ORDINANCE NO. _____

AN ORDINANCE OF THE CITY OF PASADENA AMENDING TITLE 17 (THE ZONING CODE) TO CHANGE THE DEVELOPMENT STANDARDS OF THE MULTIFAMILY RESIDENTIAL DISTRICTS (RM-16, 32 AND 48; CITY OF GARDENS), PARKING STANDARDS AND THE ENCROACHMENT STANDARDS

Figure 4-8.1 – Side Yard Encroachment Plane

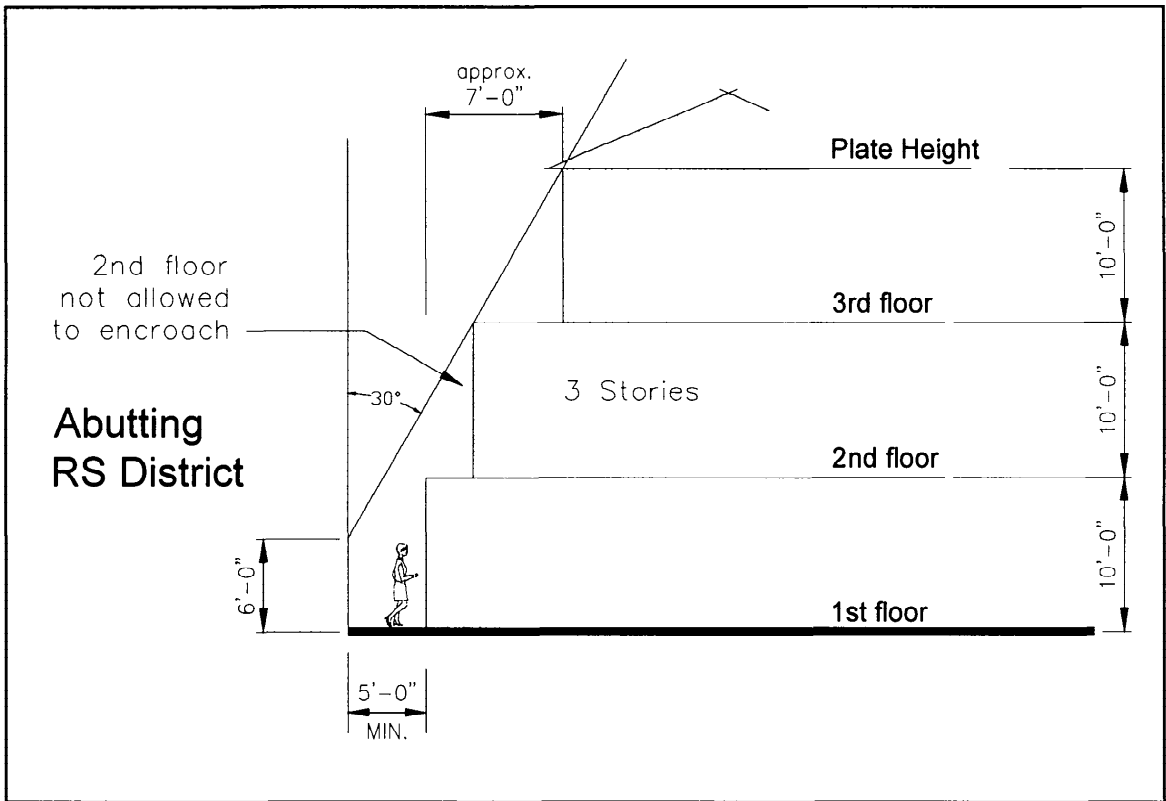
b. By adding a new paragraph 4 as follows:

“4. Multi-family projects adjacent to single-family districts. Principal and accessory structures using the City of Gardens Standards (Section 17.22.070) that adjoin an RS district along a side lot line shall provide a five-foot side yard setback and shall not be located within a side encroachment plane sloping upward and inward to the site at a 30-degree angle measured from the vertical, commencing six feet above the existing grade along the side lot line (See Figure 4-8.1). See encroachment exceptions in Table 4-2.1.”

Figure 8-5 – Podium Parking

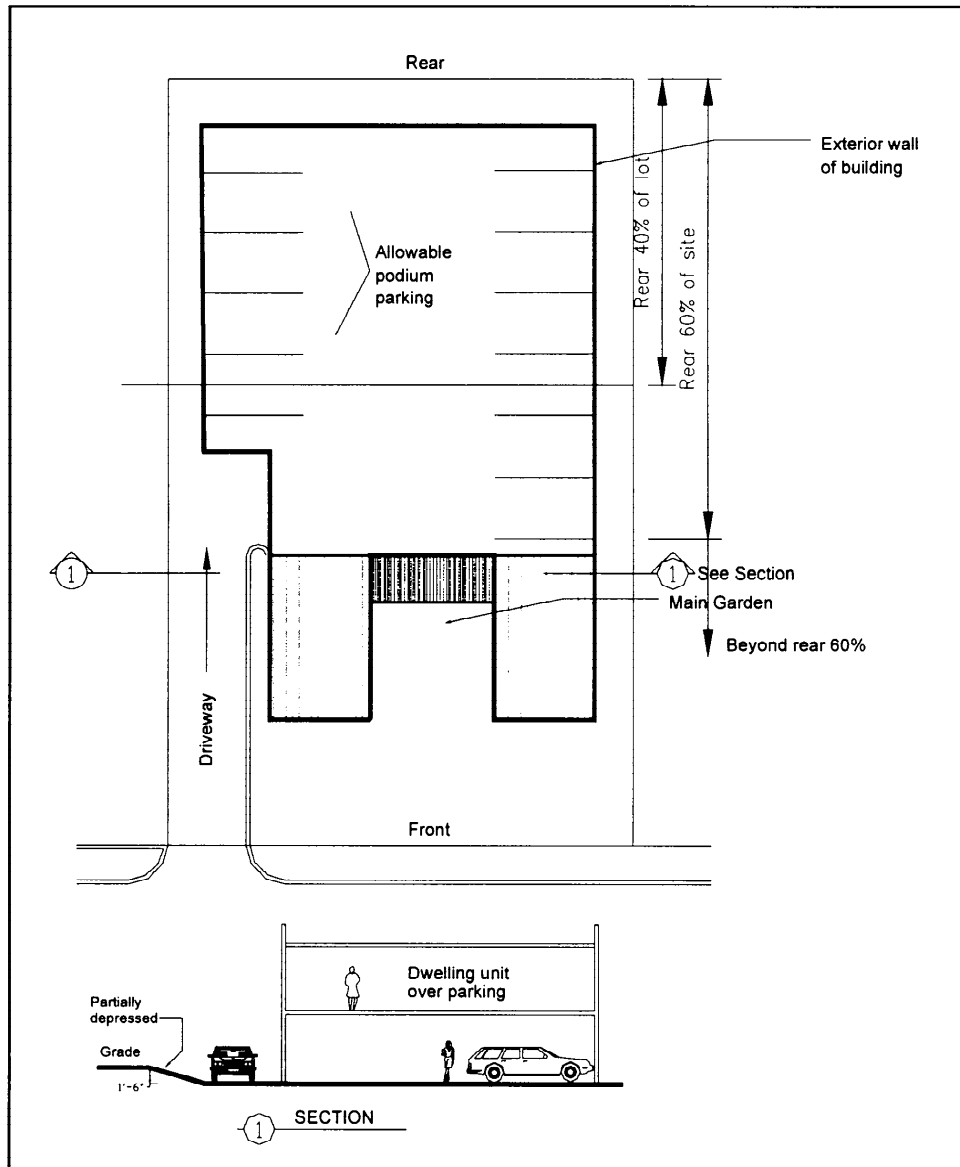
“5. Podium parking. At grade-Surface parking that is fully enclosed with a common entrance that has dwellings over. Podium parking can be at grade or partially depressed by no more than two feet below existing grade. See Figure 8-5.”

Figure 8-6 – Tuck-under Parking

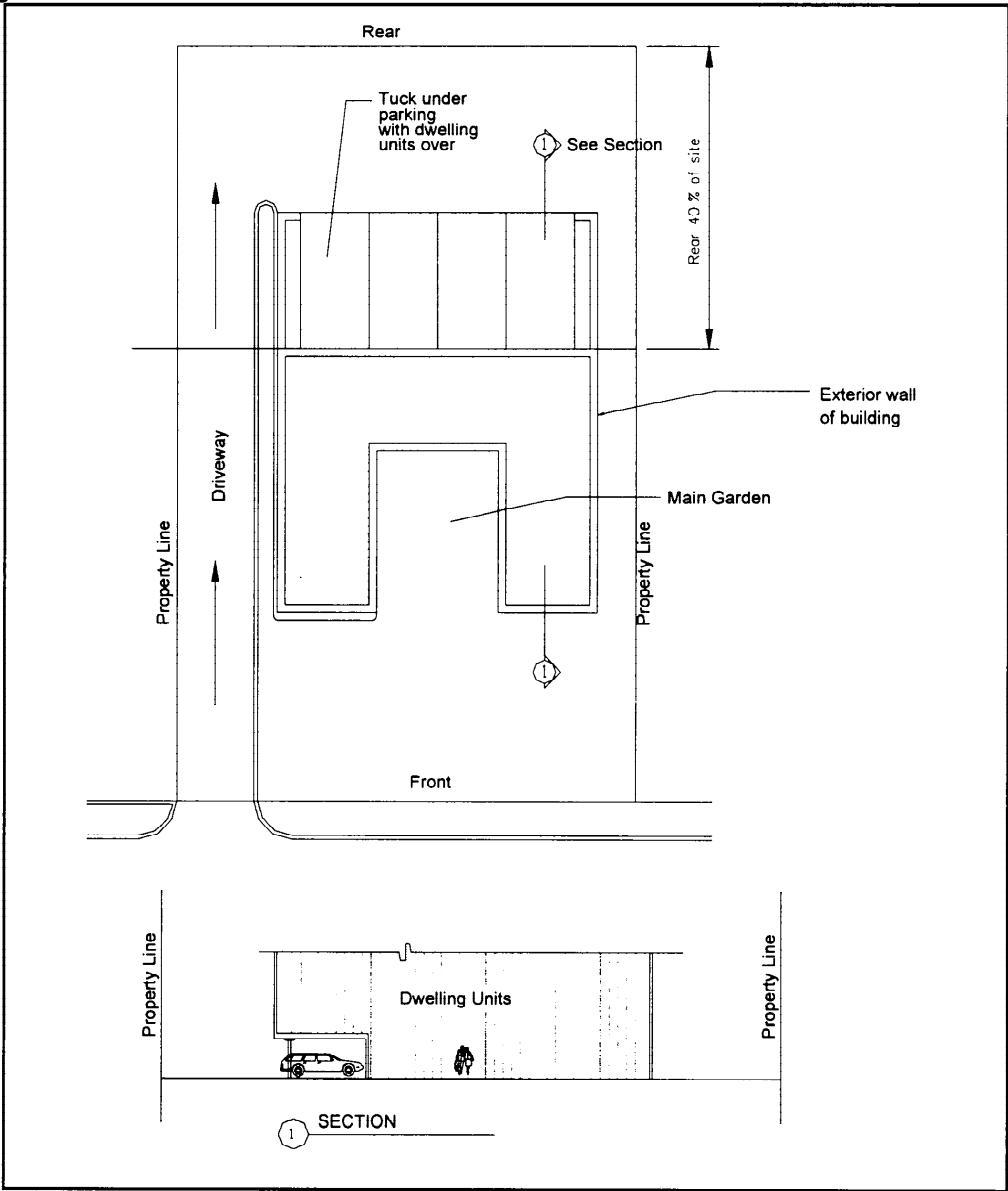
“7. Tuck-under parking. Tuck-under parking is unenclosed parking located below the unit where parking is accessed from an unenclosed driveway that may be at existing grade or below. See Figure 8-6.
